**Project Name** | BCWD Permit 25-04, Kranz Addition**Date** | March 7, 2025**To / Contact info** | BCWD Board of Managers**Cc / Contact info** | Tom & Holly Kranz / Applicant**Cc / Contact info** | Karen Kill, Administrator / BCWD**From / Contact info** | Paul Nation, PE; John Sarafolean / EOR**Regarding** | Permit Application No. 25-04 Engineer's Report

**Review based on BCWD Rules effective April 1, 2020**

**Recommendation: Approve with Conditions**

Figure 1: Site Plan

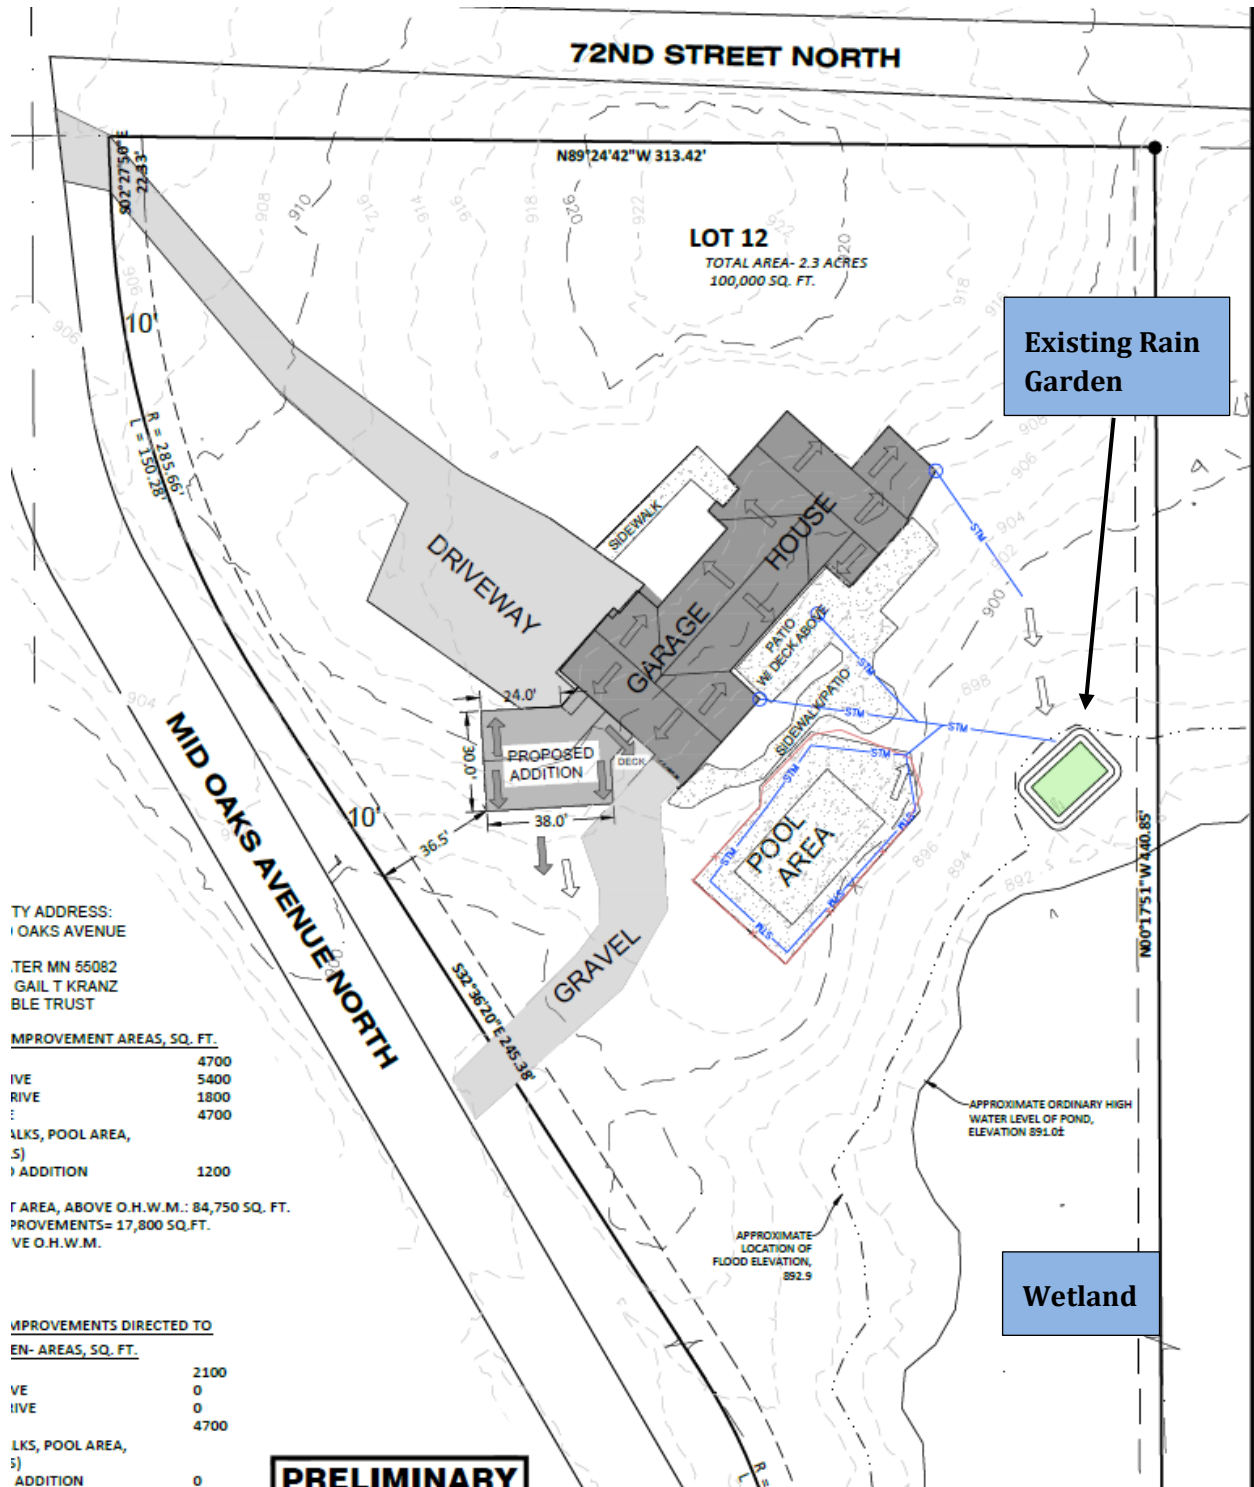
- *Perimeter control (silt fence) along downgradient edge of disturbed areas*
- *Restoration plan for disturbed soil areas including seeding.*

3-1. Provide the contact information for the erosion and sediment control responsible party during construction once a contractor is selected.

- 3-2. Provide the following changes to the erosion control plan: note the stabilization method to be used with the seeding restoration, add a note to sweep tracked sediment from the roadway at the end of each workday, add a note stating that all erosion control will be installed prior to any soil disturbance onsite.
